Subject: Issuance of Amendment No. 37 to Facility Operating  
License NPF-12 Virgil C. Summer Nuclear Station,  
Unit No. 1

AMENDMENT TO FACILITY OPERATING LICENSE

Amendment No. 37  
License No. NPF-12

SAFETY EVALUATION BY THE OFFICE OF NUCLEAR REACTOR REGULATION  
RELATED TO AMENDMENT NO. 37 TO FACILITY OPERATING LICENSE NPF-12

Figure 2.1-1  
Reactor Core Safety Limit - Three Loops in Operation

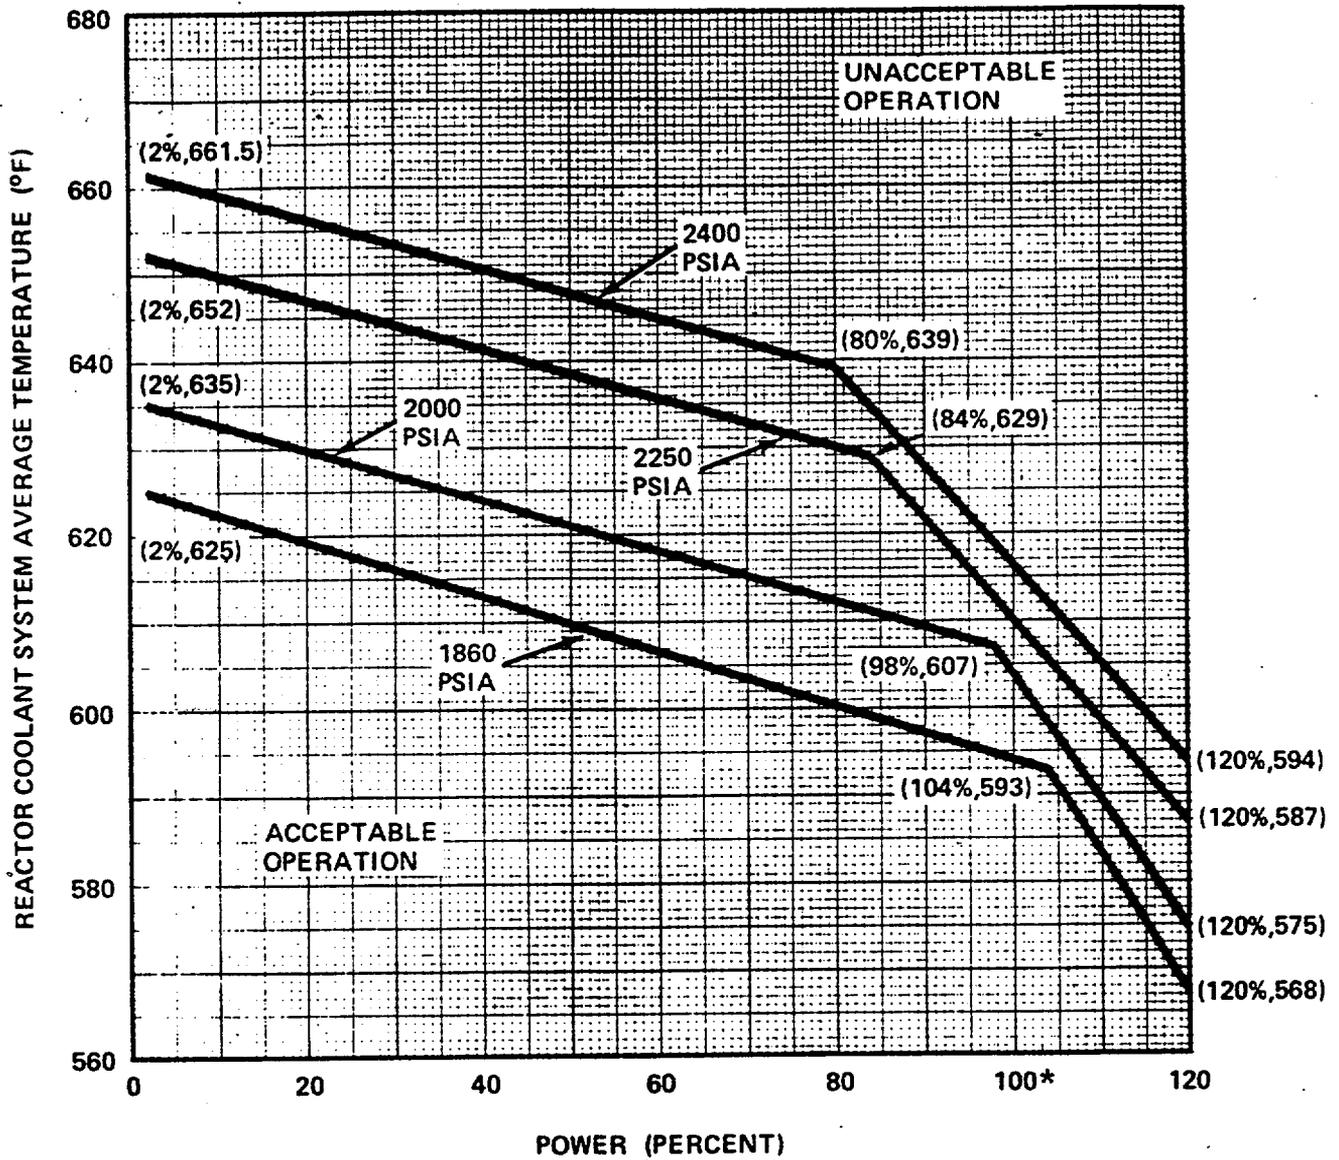
\*When operating in Region III of Technical Specification 3.2.3 (Figure 3.2-3), the restricted power level must be considered 100% RTP for this figure.

**Figure 3.2-3 RCS FLOW RATE VERSUS R**

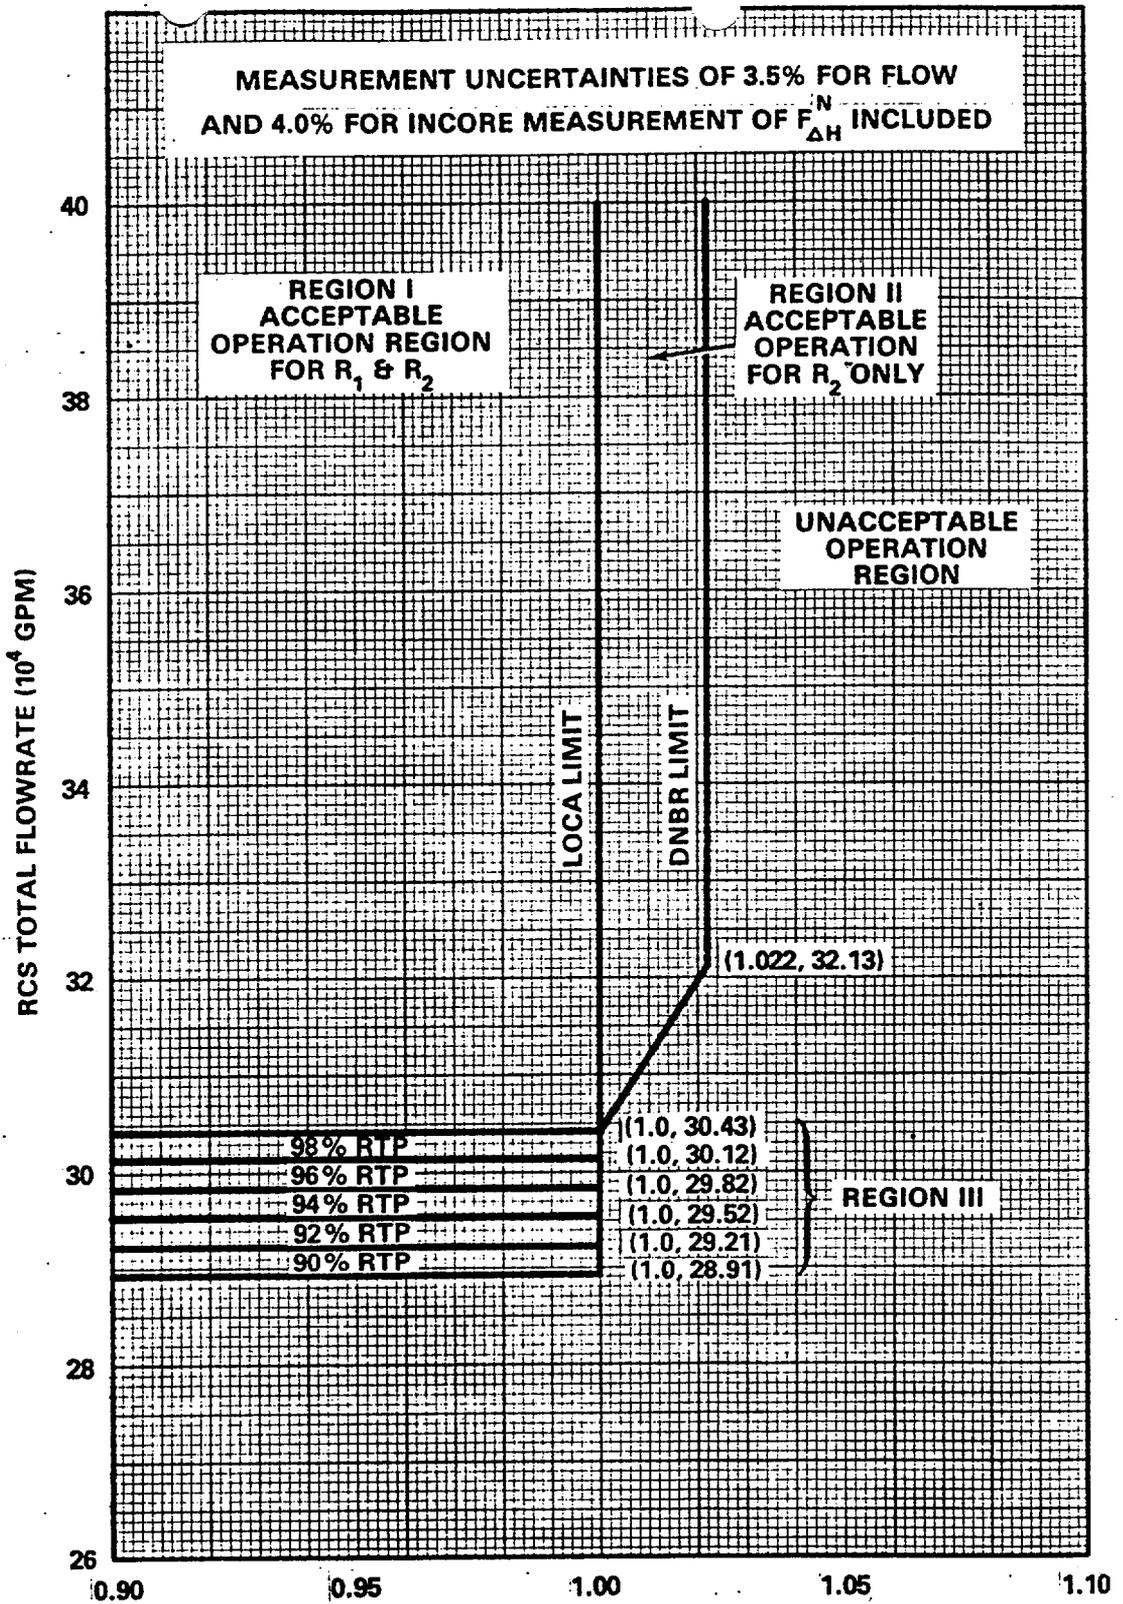
The licensee presented information (Ref. 2) to justify operation at up to 10% reduced Rated Thermal Power (RTP) if measured RCS flow is found to be less than the Thermal Design (TD) flow. This is instead of the requirement of the current Technical Specification 3.2.3, Figure 3.2-3 which limits operation to less than 5% of RTP if the measured RCS flow is less than the TD flow used in the plant safety analyses. The licensee presented information on relationships between core power, flow and departure from nucleate boiling (DNB) which resulted in a relationship between power and flow of 0.555. However, instead they proposed a conservative value of 2.0. For comparison, a staff independent calculation was made using sensitivity factors from a Battelle Pacific Northwest Laboratories Study (Reference 3). The value obtained was 0.833 instead of 0.555. However, the licensee's proposed value of 2.0 for the power to flow relationship remains conservative to

either calculation. Based on this value of 2.0, the licensee requested that a new region of acceptable operation be added to Figure 3.2-3 in the Technical Specifications for:

The licensee has modified Figure 3.2-3 such that the maximum power level for the new region is reduced by 2% for each 1% reduction in measured flow below TD flow in steps of 2% power up to a maximum of 10% reduction in rated power at 95% TD flow. The Technical Specification accident analysis results have been evaluated by the licensee to determine the impact of operating within the defined new region (Region III) of Figure 3.2-3 with the imposed restriction. It was found that sufficient margin exists in all cases to allow continued plant operation; no Technical Specification limits require modifications, including core limits, overtemperature delta T, overpower delta T, and Power Range Neutron Flux High Setpoints. This analysis took account of the increased margin to DNB because of power reduction. The licensee will restrict the power level to 100% Rated Thermal Power (RTP) for Figure 2.1-1, "Reactor Core Safety Limit - Three Loops in Operation" when operating in the defined new region (Region III) of Figure 3.2-3 at the 95% to 100% reduced TD flow conditions. The staff has found these changes to be acceptable.

**NOTE:** When operating in Region III, the restricted power levels shall be considered to be 100% of Rated Thermal Power (RTP) for Figure 2.1-1.

In conclusion, we have reviewed the analysis performed by the licensee to justify the proposed Technical Specification changes for operation of the V. C. Summer plant at the proposed 2 to 1 power/flow tradeoff for operation between 95% TD to 100% TD flow. The review included sensitivity studies on the impact of flow reduction on DNB thermal margin and DNB ratio limiting transients. The sensitivity analysis was found to be acceptable. We have found that the proposed Technical Specification changes properly account for the power/flow tradeoff and are, therefore, acceptable.
